Comments Regarding ERCOT's
Long-Term Transmission Analysis 2010 - 2030

April Pinkston, PE

ERCOT Regional Planning Group Meeting
Austin, Texas
July 15, 2011

Oncor Electric Delivery Company LLC

West Plano Proposed Project in a Highly Developed Area

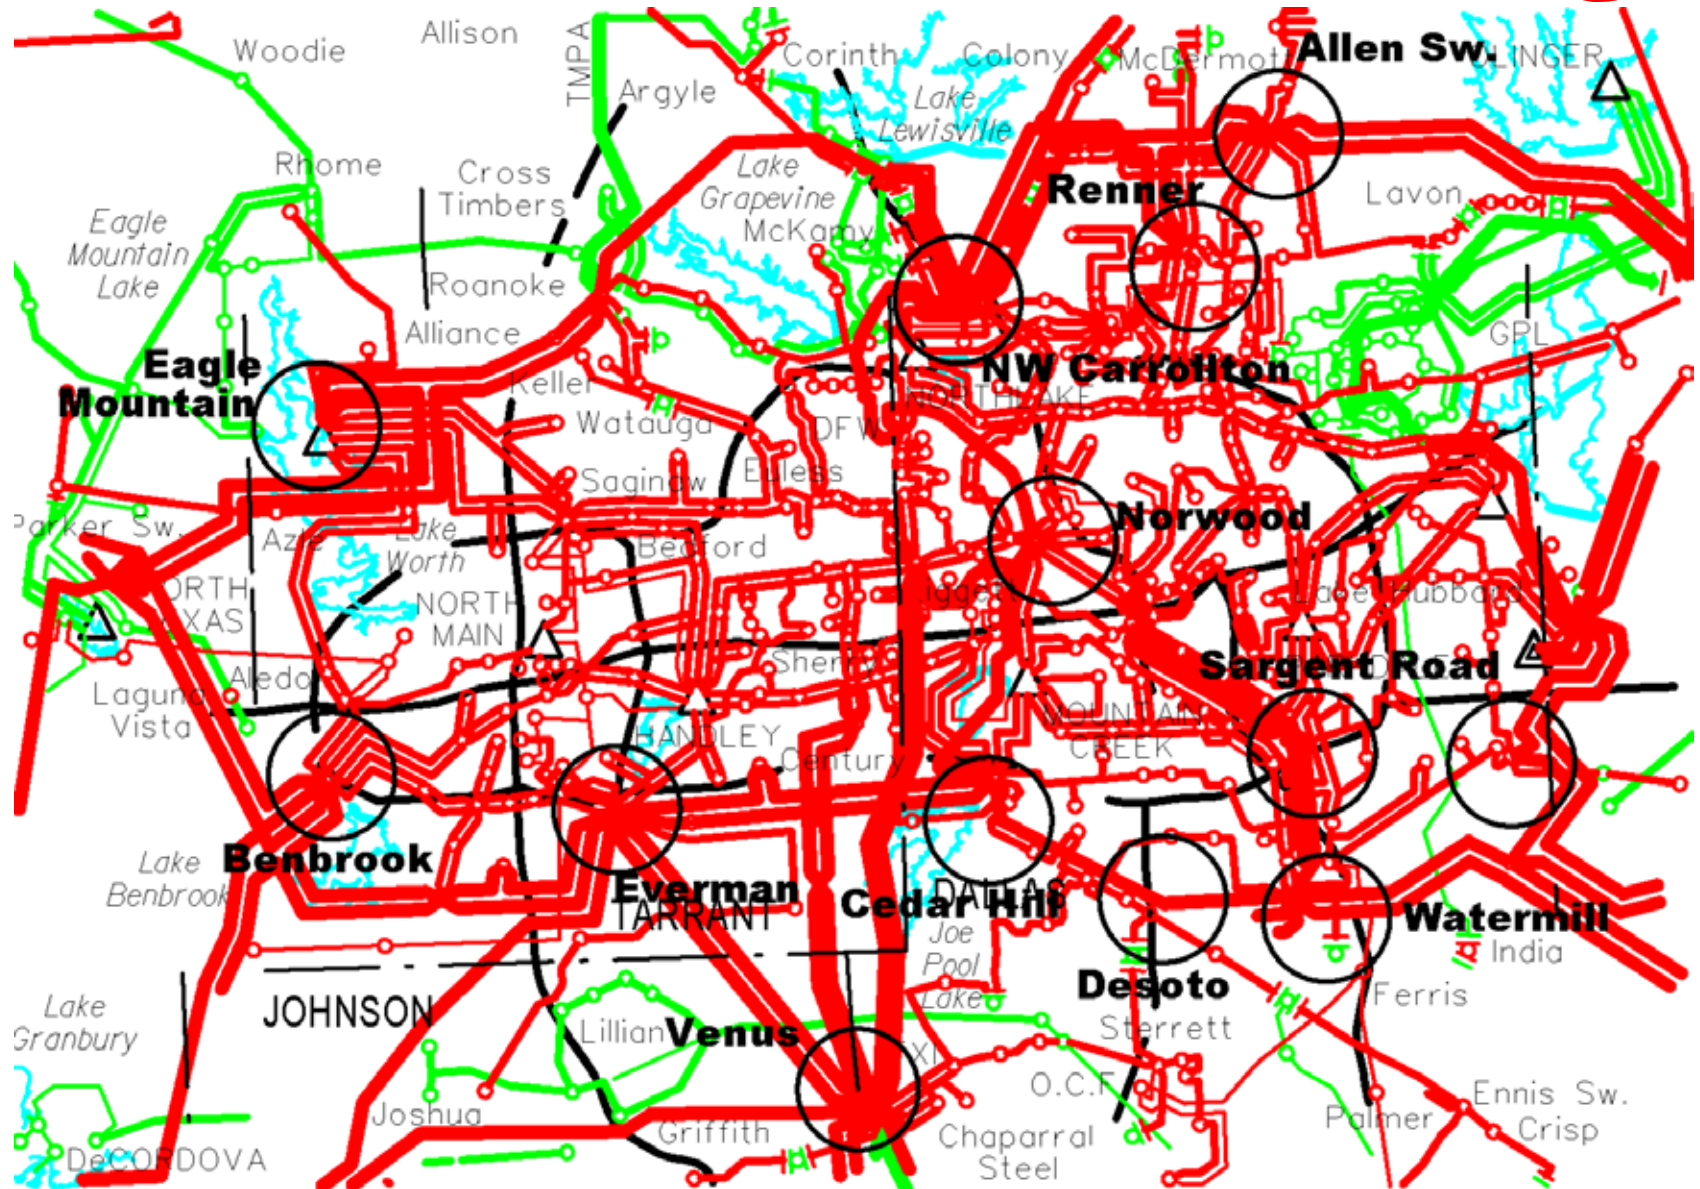
Number of habitable structures affected

HVDC Light IGBT Technology

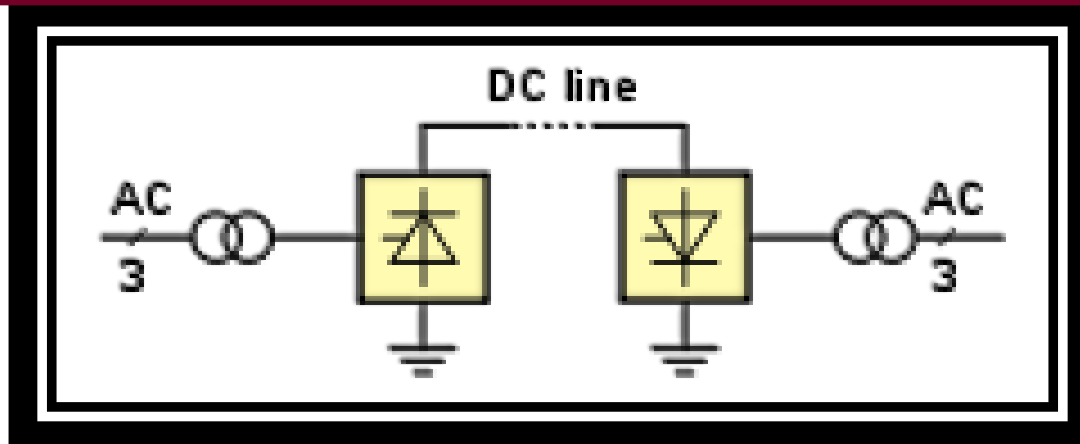
Transmit large amounts of power into Dallas/Fort Worth

Maximize flow control

Provides voltage control, damps oscillations and increases stability

Replace autotransformers by connecting from 345 kV to 138 kV

Not sensitive to line route/length (does not affect capability or flow)

Consider Three to Six 500 MW to 800 MW HVDC lines injecting into DFW
